ASSESSMENT REPORT

Project: Woolworths Austral North

Report no: ADAR_23198_ R1.0

Prepared For: Woolworths Group

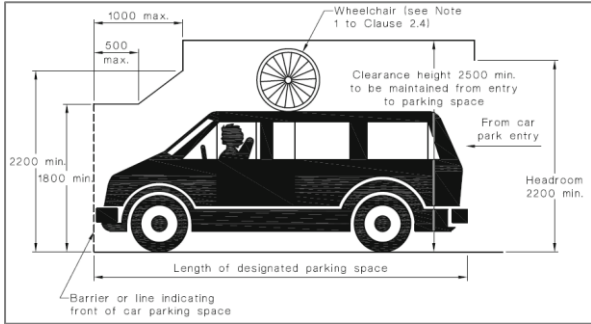
NCC / BCA Clause	DtS Provision	Compliance Commentary	Status
		<ul style="list-style-type: none"> A single step and/or tiered seating platforms are not defined as stairways and therefore have not been assessed in his report. 	
		<p>Fire Isolated Stairways (SC1)</p> <p>Compliance is readily achievable, subject to further information being provided at the design development stage.</p> <p>Key design matters to be addressed at the DD Stage –</p> <ul style="list-style-type: none"> 30% luminance contrasting nosing strips shall be provided in accordance with AS1428.1-2009 to the fire-isolated stairways. Handrails are to comply with clause 12 of AS1428.1-2009. 	CRA
		<p>Passing and Turning Bays</p> <p>Compliance is readily achievable, subject to further information being provided at the design development stage and resolution of the following:</p> <p>A 180° turning space (1,540mm X 2,070mm) is not provided within 2m of the end of an accessway / at 20m intervals as indicated below:</p> <p>External 1:14 ramp located along the south-eastern boundary</p>	CRA

NCC / BCA Clause	DtS Provision	Compliance Commentary	Status
		 <p>Common corridor at First Floor commercial lift lobby</p> <p>Compliance Options –</p> <ul style="list-style-type: none"> Provide the prescribed turning space at max. 20m intervals by increasing the width of one of the landings

NCC / BCA Clause	DtS Provision	Compliance Commentary	Status
		<p>to 1540mm (currently 1200mm) to the external ramp; and</p> <ul style="list-style-type: none"> Provide prescribed turning space within 2m of the end of the common corridor at first floor, or Where DtS compliance cannot be achieved a performance-based assessment / Performance Solution may be explored. Note this will be subject to approval from the relevant project stakeholders and further co-ordination at the design development stage. <p>Key design matters to be addressed at the DD Stage –</p> <ul style="list-style-type: none"> Refer to extracts below for AS1428.1 Implementation guide: <ul style="list-style-type: none"> (a) Passing bays:
